# Service Information

Category <b>S</b>	<b>Repair Guidance</b>	Ref. No. R016/13A	Page 1 of 3
Coverage <input type="checkbox"/> Distributor only <input checked="" type="checkbox"/> Please inform your dealers		Date Issued February 22, 2013	
Please convey this information to your <input type="checkbox"/> Director <input checked="" type="checkbox"/> General Manager <input checked="" type="checkbox"/> Warranty Dept. <input checked="" type="checkbox"/> Parts Dept. <input checked="" type="checkbox"/> Training Dept. <input checked="" type="checkbox"/> Field Rep.		Date Revised April 24, 2013	
Applicable Model  CX-5 (KE)		Applicable Countries or Specifications  Worldwide

## Subject: Wind Noise from Rear Door while driving at 40 km/h

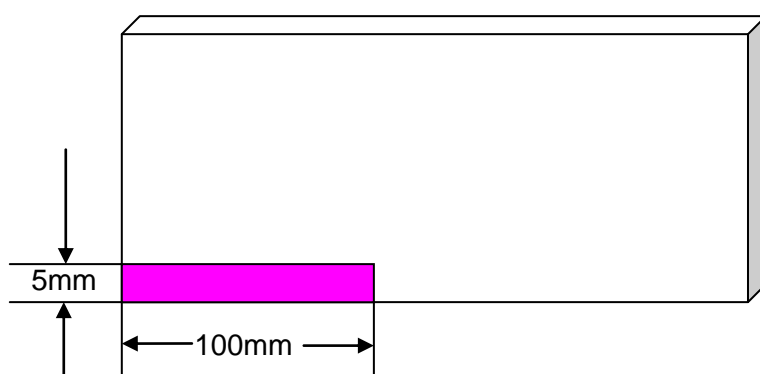
Put a masking tape as shown in the figure to cover the gap between the rear door quarter glass and the rear door garnish, and drive the vehicle to verify if the wind noise is gone.

If the noise has stopped, go to the repair procedure below. If the noise has not stopped, this Service Information is not applicable. Therefore proceed with diagnosis for different root cause.

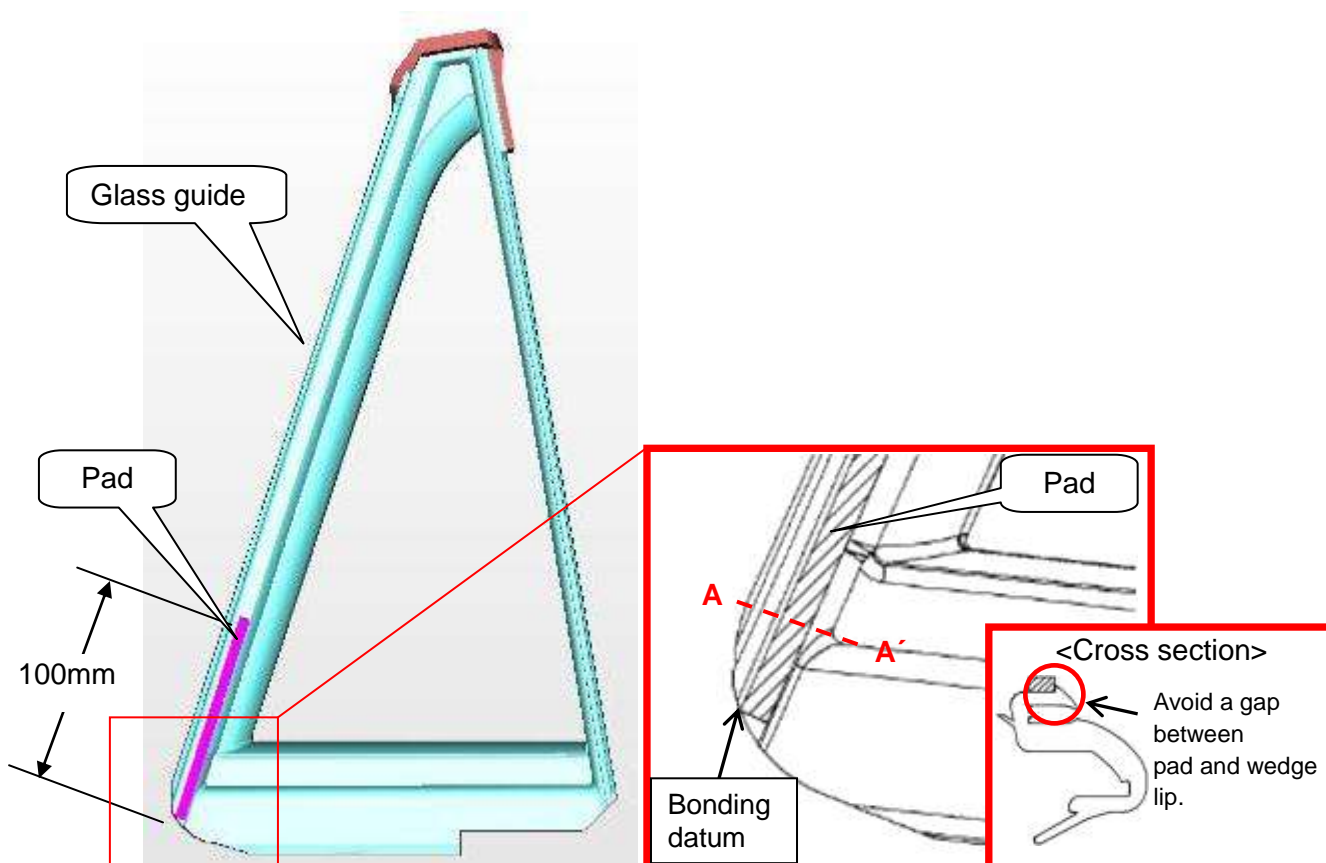
The noise is caused by a gap between the rear door quarter glass and the rear door garnish.

A pad has been attached on the rear door quarter glass guide.

1. Remove the rear door quarter glass and the rear door quarter glass guide. Refer to Workshop Manual "REAR DOOR QUARTER GLASS REMOVAL/INSTALLATION".
2. Cut the pad (NCY1-R1-433) into 5 mm x 100 mm rectangle.

3. Degrease the shaded area of the rear door quarter glass guide as indicated in the figure and attach the pad.
